Access Compliance Report Public Rights-of-Way (Curb Ramps)

Main Street: MT_GUSTIN_ST Cross Street: EDINGER_AVE Location: NE

ADA ID: RPRK220222164156 Ramp Type: Type 1 - Perpendicular Diagonal Initial Pass/Fail: Fail Overall Compliance: No Severity Score: 15

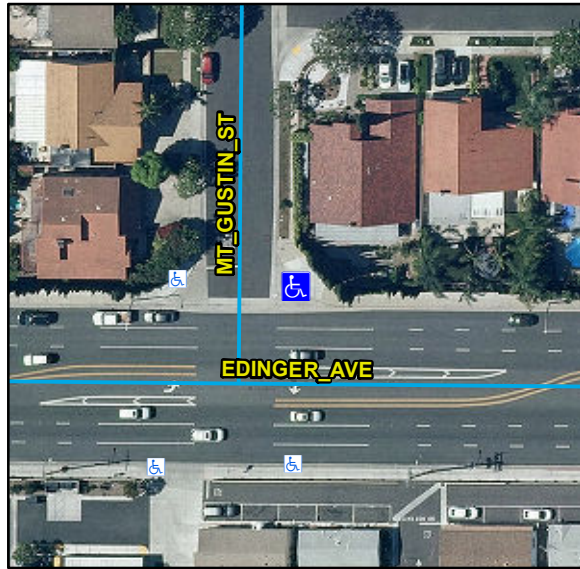
Compliance	Description	Data	Compliance	Description	Data
N/A	Ramp Length (in)	127	N/A	Flare Type LT	
Yes	Ramp Width (in)	48			N/A
No	Ramp Run Slope (%)	8.5	N/A	Flare Slope LT (%)	N/A
Yes	Ramp Cross Slope (%)	0.3	N/A	Flare Traversable LT	N/A
N/A	Landing Present	N/A	N/A	Flare Type RT	
N/A	Landing Length (in)	N/A			N/A
N/A	Landing Width (in)	N/A	N/A	Flare Slope RT (%)	N/A
N/A	Landing Run Slope (%)	N/A	N/A	Flare Traversable RT	N/A
N/A	Landing Cross Slope (%)	N/A	N/A	DWS Provided	N/A
N/A	Landing Movement Obstructed?	N/A	N/A	DWS Contrast	N/A
	Landing Movement Type	N/A	N/A	DWS Length (in)	N/A
N/A	Landing Shared	N/A	N/A	DWS Full Width	N/A
N/A	Clear Space	Yes	N/A	DWS Offset Left (in)	N/A
N/A	Clear Space To Crosswalk (in)	48	N/A	DWS Offset Right (in)	N/A
N/A	Marked Crosswalk 1	No	N/A	Marked Crosswalk 2	No
	Crossing 1 Direction	W		Crossing 2 Direction	S
	Marked Crosswalk 1 Width (in)	N/A		Marked Crosswalk 2 Width (in)	N/A

N/A	Ramp Inside Crosswalk 1	N/A	Yes	Ramp Inside Crosswalk 2	N/A
	Crossing 1 Slope (%)	8.2		Crossing 2 Slope (%)	5.8
	Crossing 1 Cross Slope (%)	1.3		Crossing 2 Cross Slope (%)	0.7
N/A	Gutter Ponding	N/A	N/A	Curb Slope	0.9
No	Gutter Lip Height (in)	0.4		Road Run Slope (%)	0.4
N/A	Gutter Run Slope (%)	N/A		Road Cross Slope (%)	0
N/A	Gutter Cross Slope (%)	N/A			
Yes	Overall Surface Condition: Acceptable		Yes	Perp Joint Present	Yes
	Cross Gutter Present?	Yes		Spandrel Present?	Yes
	Replace Cross Gutter?	No		Replace Spandrel?	No

Remove & Replace Curb Ramp With Two New Directional Ramps or Equivalent. Grind Gutter Lip.
